CLCCR Comments

**STATE CUSTOMS
COMMITTEE OF THE
REPUBLIC OF BELARUS
(31122013 – 02/17009)**

„About amendments to TIR Convention“

Sketch out of a TIR certificate.

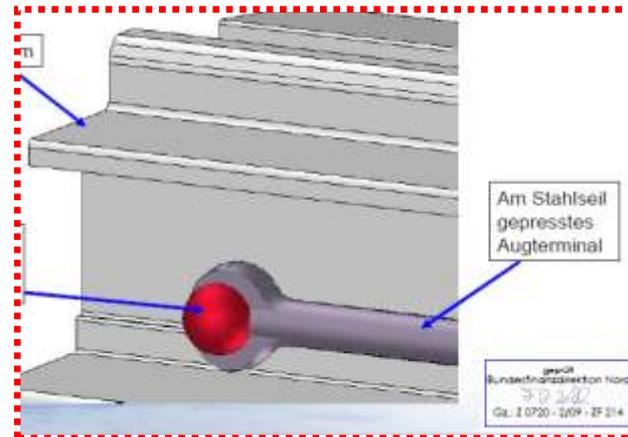
The fixing point of the fastening steel rope is completely covered and secured by the roof curtain.

Detail photo from the fixing point of the fastening steel rope at the front.

- We prepared photos from the front wall and the rear door.
- We described the constructions on both sides in detail.

Sketch out of a TIR certificate. **PATENTED**

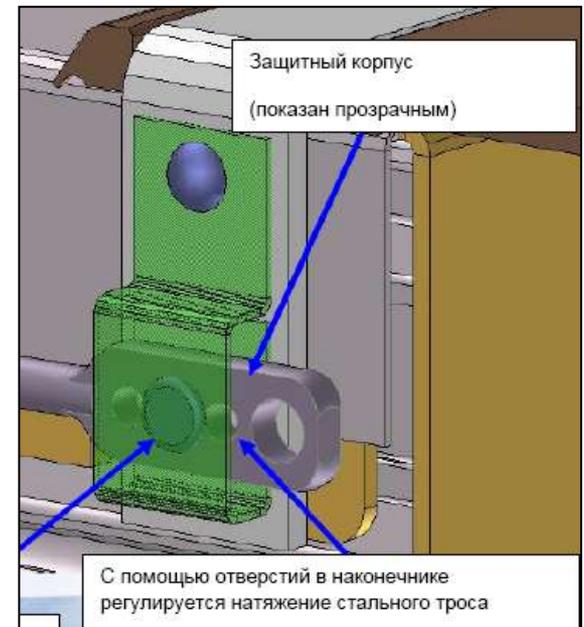
Fastening steel rope goes in the hemline.

Due to the fact that there are certainly other solutions to secure the fastening steel rope and that this system is patented from a manufacturer, this system should not be described in the TIR Handbook. If the WP30 do though, then only as example and with the remark **PATENTED**.

- We prepared photos to explain the way how to fit the “fastening steel rope” to the front and to the rear of the trailer. (The system to the rear is PATENTED; other solutions are possible.)

Photo from a trailer (to see where the TIR cable, and the fastening steel rope are located)

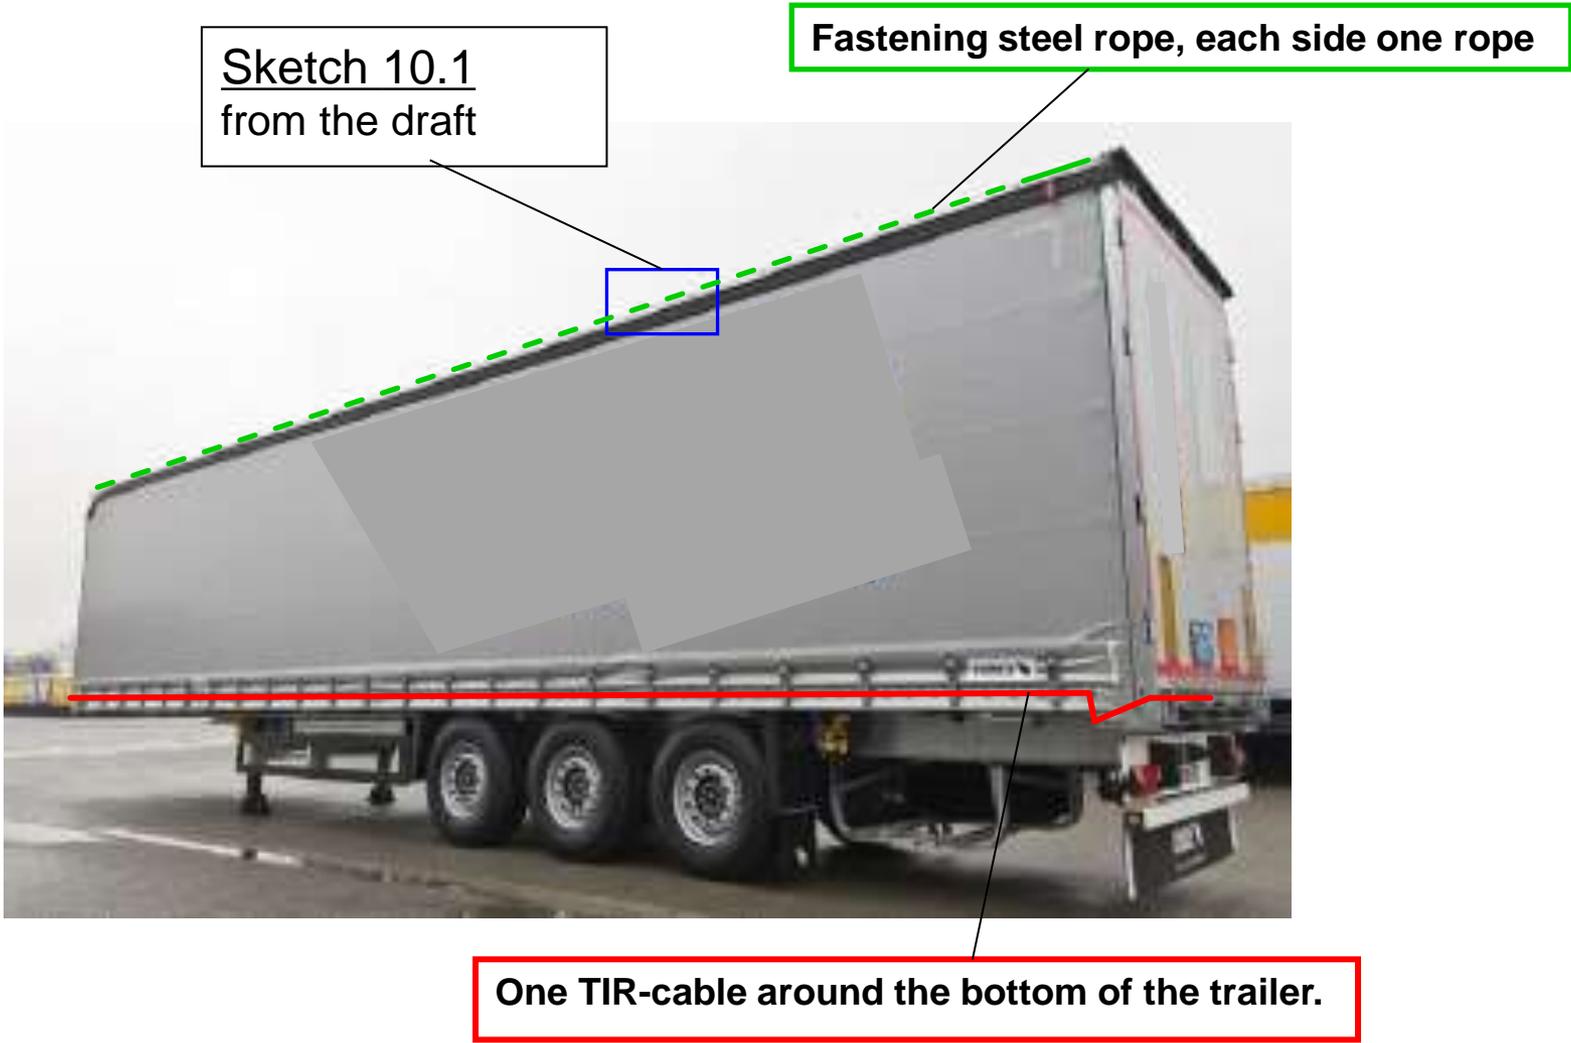
How to close the roof and how to tension the fastening steel rope ?

(These are two different actions.)

Tensioning device on the lever mechanism. By folding down the tensioning device, the steel rope will tension.

Sliding carriage from the roof curtain (closed) with locking system (inside).

- We described a trailer with “TIR- cable” (only at the bottom) and with the constructive solution, the “fastening steel rope” (only at the top).
- We coloured the “TIR- cable” (red) and the “fastening steel rope” (green). We add this as amendment to the draft.

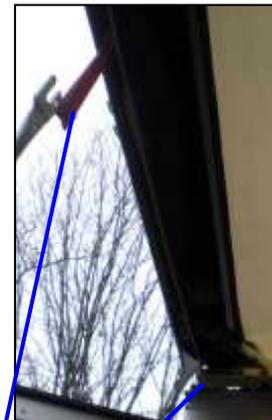
- Roof carriage closed.
- Tensioning device open.

To open it, pull.

- Roof carriage open.
- Tensioning device open.

- Roof carriage closed.
- To close tensioning device, pull.

- Roof carriage closed.
- Tensioning device closed.
- By closing and locking the doors, the systems are secure.

This could be only an example! Other manufacturers, different systems!

- We prepared photos to explain, one idea (solution) how to open the roof and how to tension the “fastening steel rope”. Other solutions to secure the roof are possible.
